MIL-R-22618(WEP)
AMENDMENT-1
15 AUGUST 1963

MILITARY SPECIFICATION

Release, Bomb Shackle, Aero 7A Series
and
Release, Bomb Rack Aero 7B Series

This amendment forms a part of Military Specification MIL-R-22618(WEP) dated 15 September 1960 and has been approved by the Bureau of Naval Weapons, Department of the Navy.

Figure 3

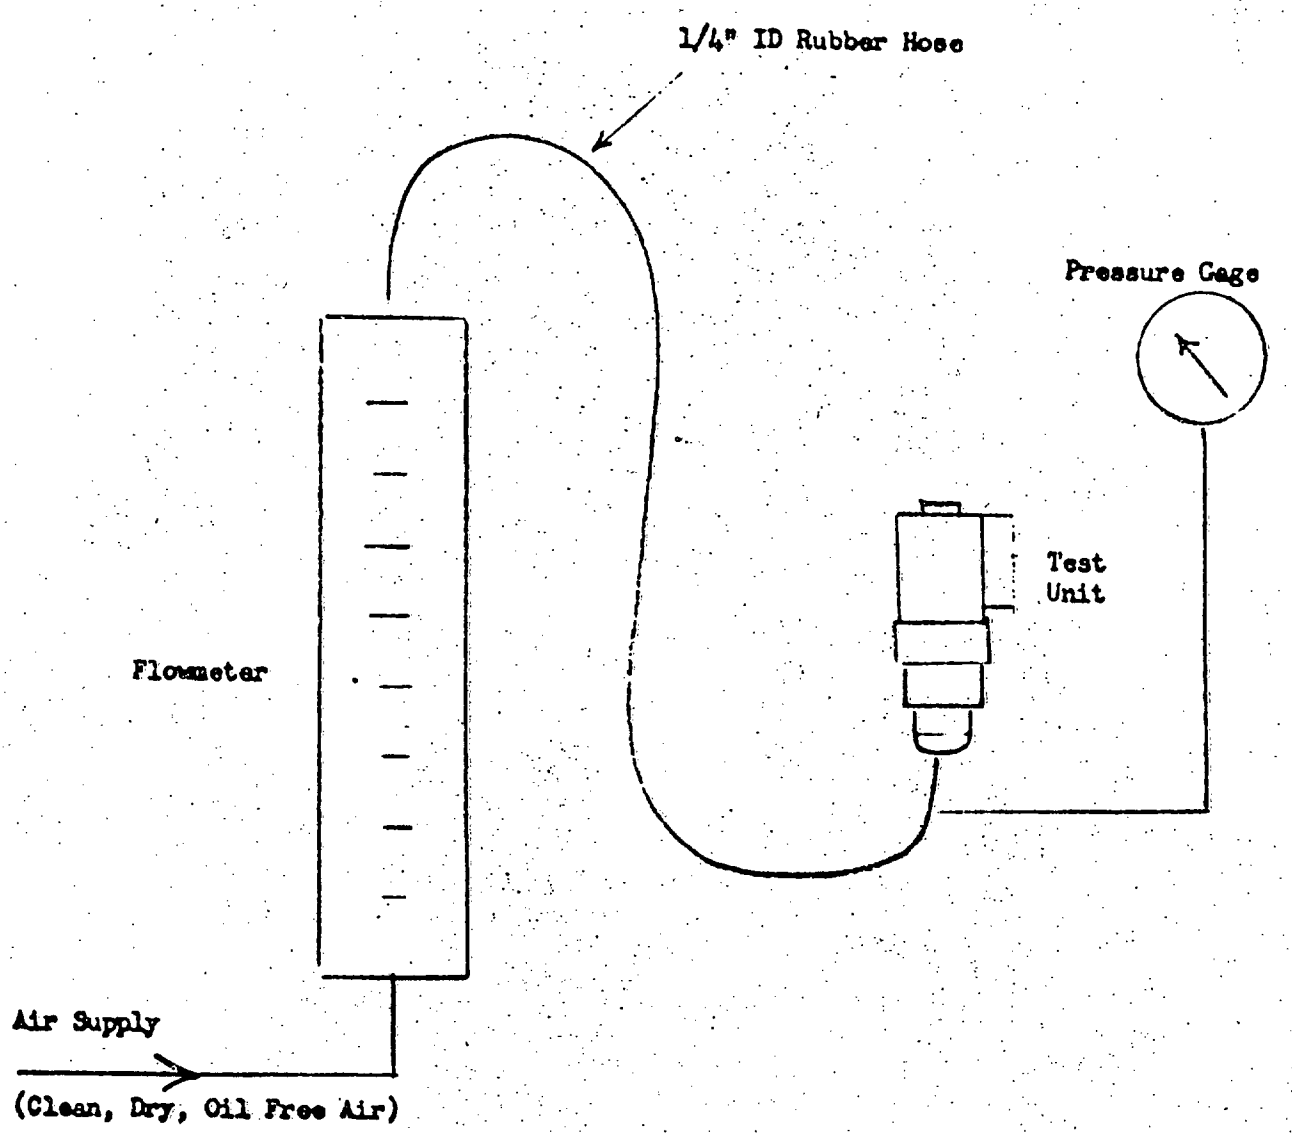
"4.4.19 Leakage Test - Each release unit shall be leak tested at 5 PSIG internal air pressure using clean, dry, oil free air. The maximum allowable leakage rate shall not exceed 0.7 standard Liters per minute (SLPM) measured after 30 seconds of pressurization. A cap 60A121A3 shall be suitably drilled and tapped for a pressure fitting to permit pressurizing the release unit to 5 PSIG. This test shall be conducted with the release unit in a cocked position. Units which leak in excess of 0.7 SLPM may be immersed in water, while pressurized, to aid in locating the source of leakage. This test shall be performed prior to final assembly of the cap 60A121A3 with "LOCKTITE". A suitable air flow indicating flowmeter (Fisher Porter Manostat Model FM 1044B or equal) shall be used in the air supply line to measure the leakage (Fig. 3).

Page 12: Add

"Figure 3."
